Certificate of Appropriateness

827-829 E. BRADY ST. UNIT

Brady Street Historic District

PTS ID 105376 COA

Lower Façade at Alley

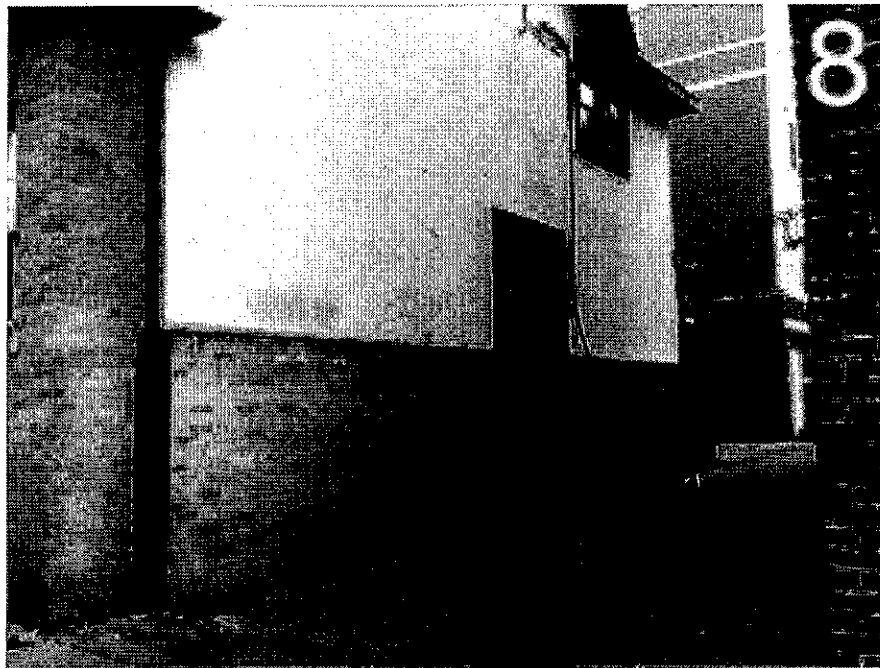
As part of the rehabilitation plan for 827-829 East Brady Street, the applicant proposes to demolish a rear concrete block addition behind the residential portion of the buildings. It is not large enough to serve as a garage but may have served as storage. It is only barely visible from Brady Street.

The demolition of this wing would be acceptable according to the guidelines of the Brady Street Historic District and the Historic Preservation Ordinance 320-21-11-h. The wing is not of any architectural or historic significance, it does not display quality material and craftsmanship, it does not contribute to the neighborhood or general street appearance, and it is to be replaced with new open porches for the apartments within.

The demolition is to be carried out with minimal damage to the existing structure.

Rear from Alley

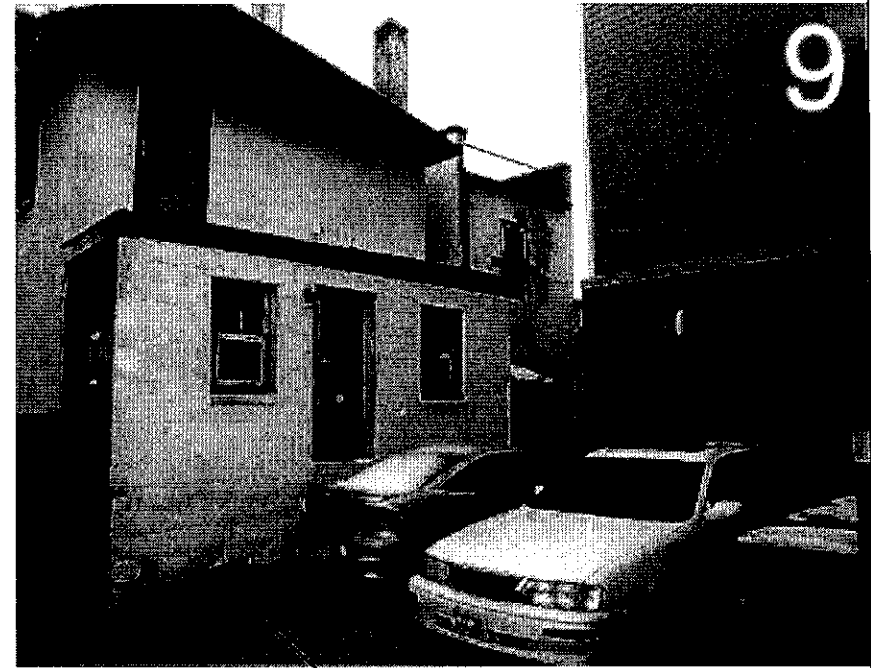
Concrete block addition as seen from Brady Street. Addition as seen from rear.

**Metal or
wood flush
doors**

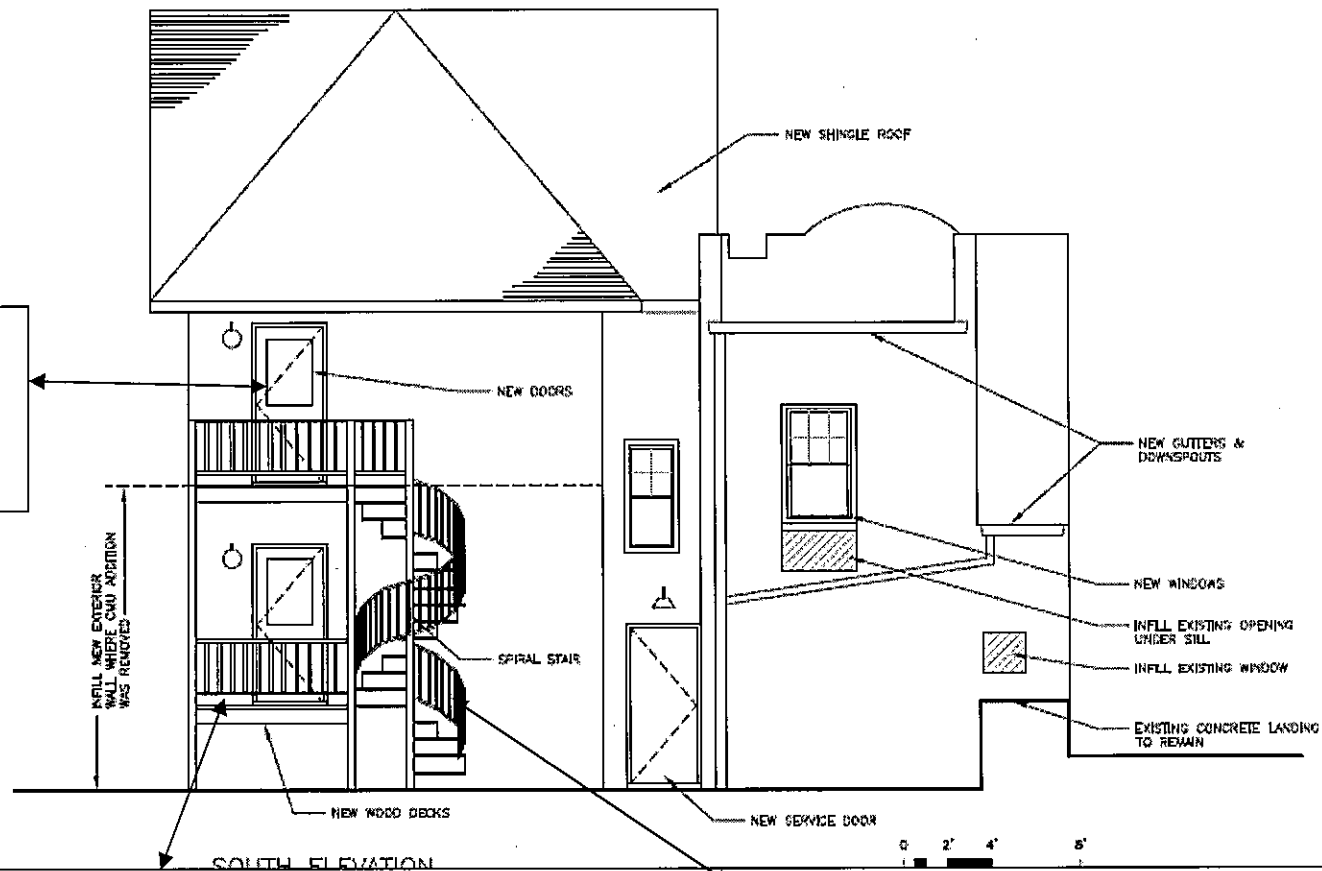
Porches will be made of wood, spiral stairs will be made of metal and there will be metal flush doors with half lights. Wood doors can also be used and would be preferable.

The doors to the deck will be flush metal with a 1/2 light. It is preferable to have a 1/2 light wood door and full light wood storm door rather than aluminum, unless metal is required for fire codes.
